IN THE MATTER notices of requirement under section 168 of the RMA for the construction, operation, maintenance and improvement of approximately 11.5km of new State Highway between Ashhurst and Woodville.

BY **NZ TRANSPORT AGENCY**
Requiring Authority

**EVIDENCE OF MARK AARON READ
ON BEHALF OF PALMERSTON NORTH CITY COUNCIL**

15 March 2019

APPENDIX B: FATAL AND SERIOUS CYCLISTS CRASHES BY SHOULDER WIDTH

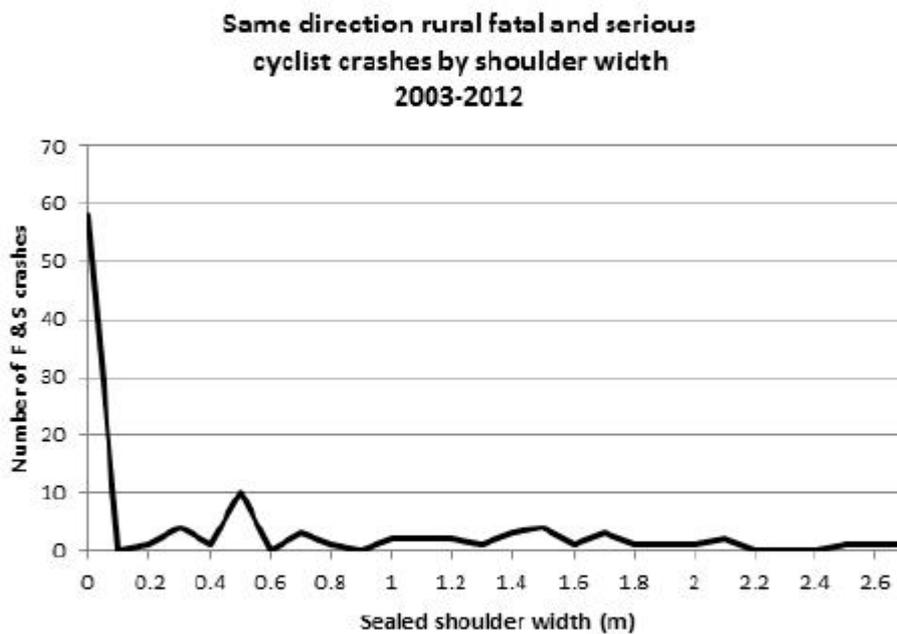
- 4.5 Sealed shoulder widths for both the Saddle Road and Pahiatua Track are predominantly between 0m and 0.5m. Both routes have discrete sections which provide a wider sealed shoulder width. These are mostly on the Saddle Road where there has been a greater level of investment since the previous Manawatu Gorge closure in 2011/12.

- 4.6 **Appendix B** includes an extract from the *Safer Journeys for People Who Cycle* document published in December 2014. The figure demonstrates that the lack of shoulder width results in a greater risk to cyclists.
